May 14, 2009

Scoping Issues: Bay Delta Conservation Plan EIS/EIR

**Location of Air Bubble/Acoustic Barrier to be Considered**

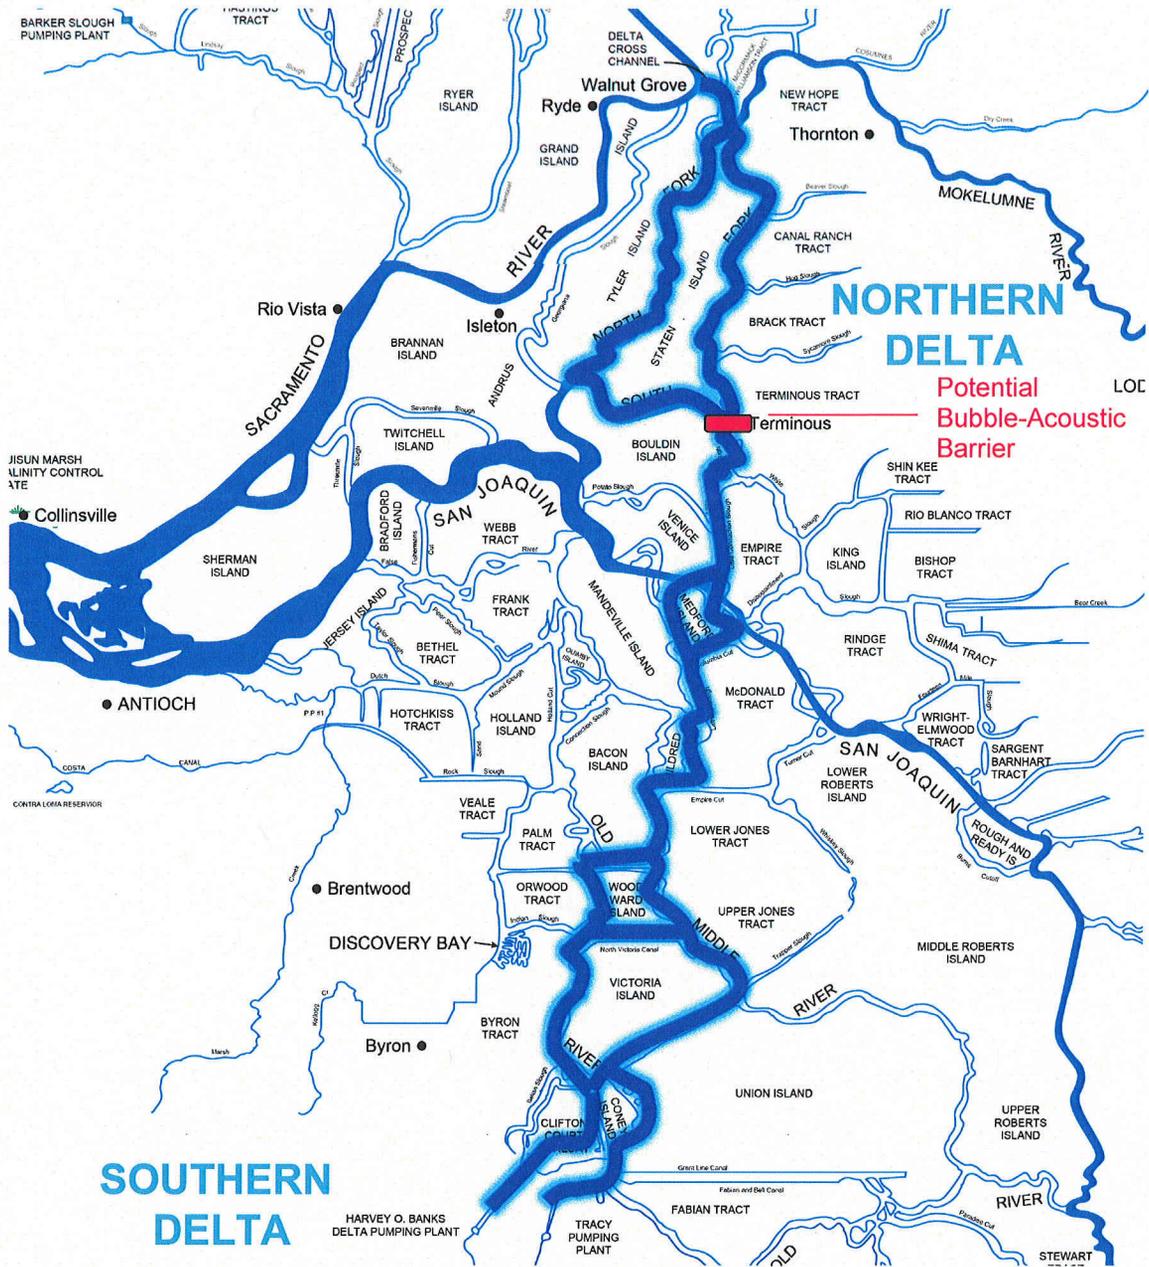
- Another structural option would be construction of a fish screen and boat lock at Terminous to prevent fish passage from the South Fork of the Mokelumne River into Little Potato Slough. This option would also facilitate the downstream migration of juvenile salmonids originating in the Mokelumne and Cosumnes Rivers. Alternatively an acoustic bubble barrier should be considered at the entrance to Little Potato Slough off the Mokelumne South Fork (see Attachment 3) to keep fish from being entrained in the through Delta conveyance corridor.<sup>1</sup>

**Variation in Mokelumne Salmon Outmigration by Year Type**

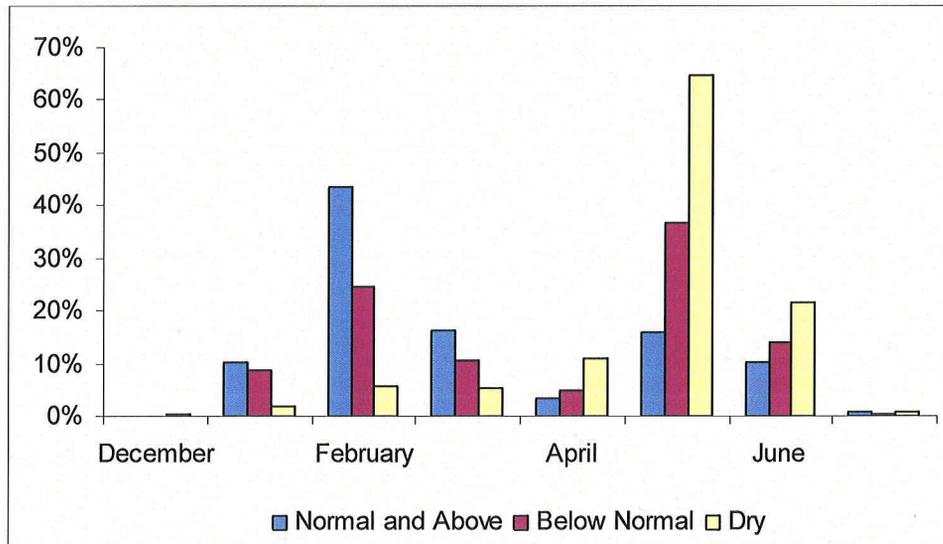
River, including changes to operating gates and pumping rates during fish-sensitive periods. Fish-sensitive periods vary by hydrologic conditions, as illustrated in Attachment 4, which illustrates changes in Mokelumne salmon outmigration based on water year type.
